## **CITY OF ONTARIO DEVELOPMENT ADVISORY BOARD**

### **AGENDA**

**July 18, 2022**

- B. ENVIRONMENTAL ASSESSMENT AND DEVELOPMENT PLAN REVIEW FOR FILE NO. PDEV19-047:** A hearing to consider a Development Plan to construct 10 detached single-family dwellings on 10 vacant parcels totaling approximately 1.83 acres of land generally located at the northwest corner of Olive Street and Orange Avenue, within the LDR-5 (Low Density Residential – 2.1 to 5.0 du/ac) zoning district. The project is categorically exempt from the requirements of the California Environmental Quality Act (CEQA) pursuant to Section 15332 (Class 32, In-fill Development Projects) of the CEQA Guidelines. The proposed project is located within the Airport Influence Area of Ontario International Airport and was evaluated and found to be consistent with the policies and criteria of the Ontario International Airport Land Use Compatibility Plan (ALUCP); (APNs: 0108-481-18, 0108-481-19, 0108-481-20, 0108-481-21, 0108-481-22, 0108-481-23, 0108-481-24, 0108-481-25, 0108-481-26, and 0108-481-27) **submitted by Texton Construction Co., Inc. Planning Commission action is required.**

**SHEET INDEX MAP**  
 SCALE: 1" = 100'

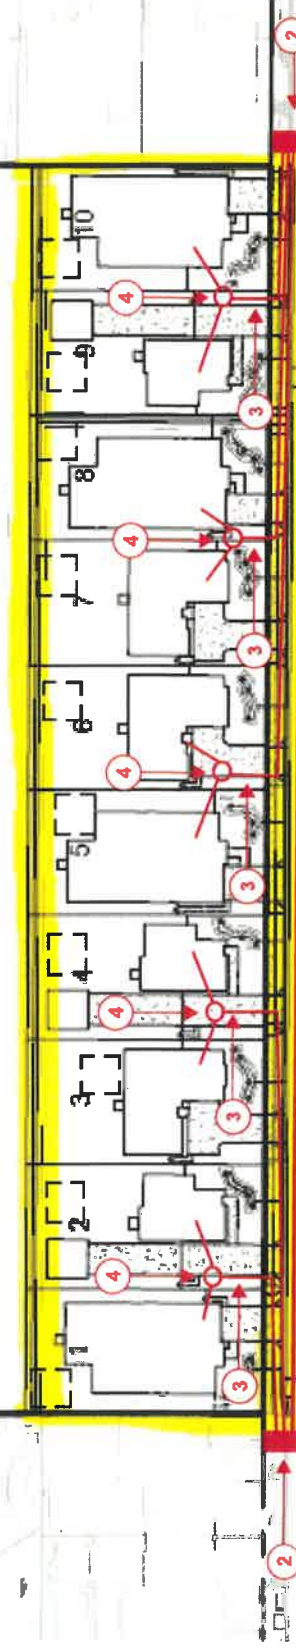
**CONSTRUCTION NOTE 1**  
 CONSTRUCT (INSTALL) FIBER OPTIC CONDUIT AT A MINIMUM DEPTH OF 36". TRENCHING SHALL BE PER CITY STANDARD 1306. TWO (2) 2" HDPE SDR-11 (SMOOTHWALL) ROLL PIPE (1 ORANGE AND 1-ORANGE WITH BLACK STRIPE) OR EQUIVALENT, ALL UNUSED CONDUITS/DUCTS/MICRODUCTS SHALL BE PROTECTED WITH DUCTS WITH PLUGS THAT PROVIDE A POSITIVE SEAL. DUCTS THAT ARE OCCUPIED SHALL BE PROTECTED WITH INDUSTRY ACCEPTED DUCT SEAL COMPOUND. CONDUIT BANK REQUIRES (1) 12AWG HIGH STRENGTH (MIN. BREAK LOAD 452#) COPPER-CLAD STEEL W/30MIL HDPE ORANGE INSULATION FOR LOCATE/TRACER WIRE.

**CONSTRUCTION NOTE 2**  
 ALL HANDHOLES (H-302) (RCA004836-00944) NEWBASIS; LESS THAN OR EQUAL TO 432 STRANDS, PER CITY STANDARD 1306. HANDHOLES SWEEPING INTO HANDHOLES SHALL ENTER IN FLUSH WITH THE CUT OUT MOUSE HOLES, ALIGNED PARALLEL TO THE BOTTOM OF THE BOX AND COME IN PERPENDICULAR TO THE WALL OF THE BOX. CONDUITS SHALL NOT ENTER AT ANY ANGLE OTHER THAN PARALLEL, PROVIDE 5" MIN CLEARANCE FROM EXISTING PROPOSED UTILITIES. ALL HANDHOLES WILL HAVE 1/4 INCH GALVANIZED WIRE BETWEEN THE HANDHOLES AND THE GRAVEL ITS PLACED ON.

**CONSTRUCTION NOTE 3**  
 FROM THE NEAREST HANDHOLE TO THE BUILDING ENTRANCE, DESIGN AND INSTALL FIBER OPTIC CONDUIT AT A MINIMUM DEPTH OF 36-INCHES. TRENCHING SHALL BE PER CITY STANDARD FOR COMMERCIAL BUILDINGS: (1) 2-INCH HDPE SDR-11 (SMOOTHWALL) ROLL PIPE (ORANGE) DUCT, INSTALL LOCATE/TRACER WIRES MINIMUM 12AWG WITHIN CONDUIT BANK AND FIBER WARNING TAPE 16-INCH ABOVE THE UPPERMOST DUCT.

**CONSTRUCTION NOTE 4**  
 INSTALL FIBER OPTIC FLOWERPOT HH-FP (PLA1000101-00002) NEWBASIS, PER CITY STANDARD 1316 CONDUITS SWEEPING INTO THE FLOWERPOT SHALL ENTER IN FLUSH WITH THE CUT OUT MOUSE HOLES ALIGNED PARALLEL TO THE BOTTOM OF THE BOX. CONDUITS SHALL PROTRUDE FROM THE BASE OF THE FLOWERPOT, WITH 2" OF CLEARANCE FROM THE GRAVEL BASE. ALLOW MINIMUM 8" OF CLEARANCE BETWEEN THE CONDUIT AND FLOWERPOT LID FOR CABLE MANAGEMENT. PROVIDE 5" MIN CLEARANCE FROM EXISTING PROPOSED UTILITIES. ALL HANDHOLES WILL HAVE 1/4 INCH GALVANIZED WIRE BETWEEN THE HANDHOLES AS THE GRAVEL BASE. ALL HANDHOLES WITH A 1316MM MICRODUCT WILL EXTEND FROM THE FLOWER POT TO EACH DWELLING UNIT.

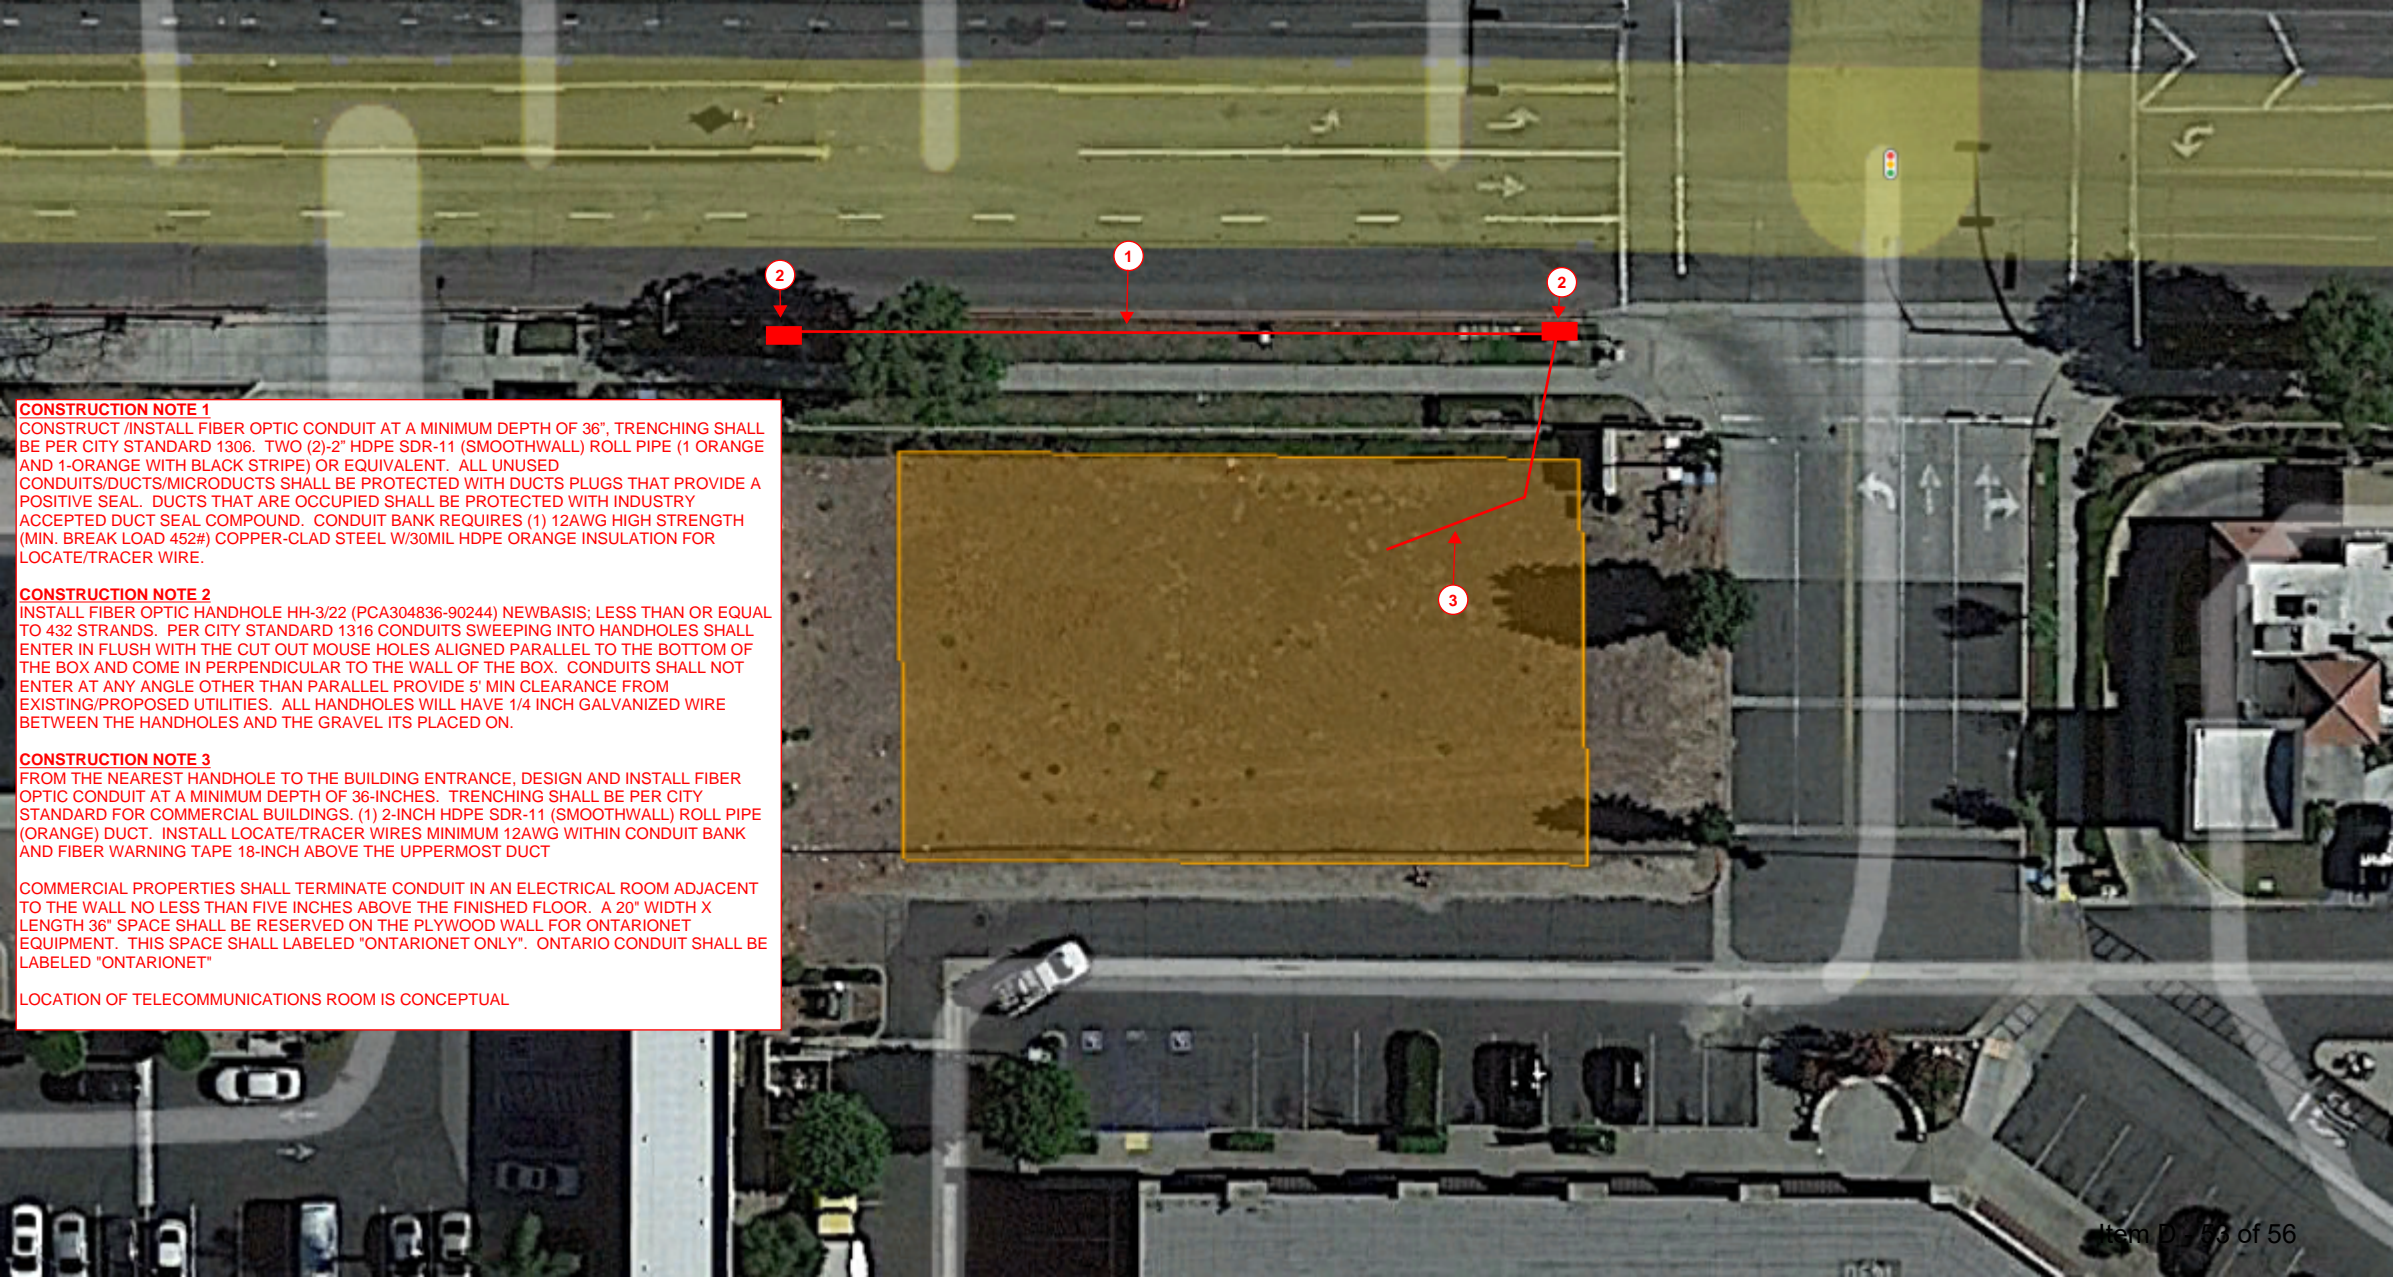
**CONSTRUCTION NOTE 1**  
CONSTRUCT /INSTALL FIBER OPTIC CONDUIT AT A MINIMUM DEPTH OF 36", TRENCHING SHALL BE PER CITY STANDARD 1306. TWO (2)-2" HDPE SDR-11 (SMOOTHWALL) ROLL PIPE (1 ORANGE AND 1-ORANGE WITH BLACK STRIPE) OR EQUIVALENT. ALL UNUSED CONDUITS/DUCTS/MICRODUCTS SHALL BE PROTECTED WITH DUCTS PLUGS THAT PROVIDE A POSITIVE SEAL. DUCTS THAT ARE OCCUPIED SHALL BE PROTECTED WITH INDUSTRY ACCEPTED DUCT SEAL COMPOUND. CONDUIT BANK REQUIRES (1) 12AWG HIGH STRENGTH (MIN. BREAK LOAD 452#) COPPER-CLAD STEEL W/30MIL HDPE ORANGE INSULATION FOR LOCATE/TRACER WIRE.

**CONSTRUCTION NOTE 2**  
INSTALL FIBER OPTIC HANDHOLE HH-3/22 (PCA304836-90244) NEWBASIS; LESS THAN OR EQUAL TO 432 STRANDS. PER CITY STANDARD 1316 CONDUITS SWEEPING INTO HANDHOLES SHALL ENTER IN FLUSH WITH THE CUT OUT MOUSE HOLES ALIGNED PARALLEL TO THE BOTTOM OF THE BOX AND COME IN PERPENDICULAR TO THE WALL OF THE BOX. CONDUITS SHALL NOT ENTER AT ANY ANGLE OTHER THAN PARALLEL PROVIDE 5' MIN CLEARANCE FROM EXISTING/PROPOSED UTILITIES. ALL HANDHOLES WILL HAVE 1/4 INCH GALVANIZED WIRE BETWEEN THE HANDHOLES AND THE GRAVEL ITS PLACED ON.
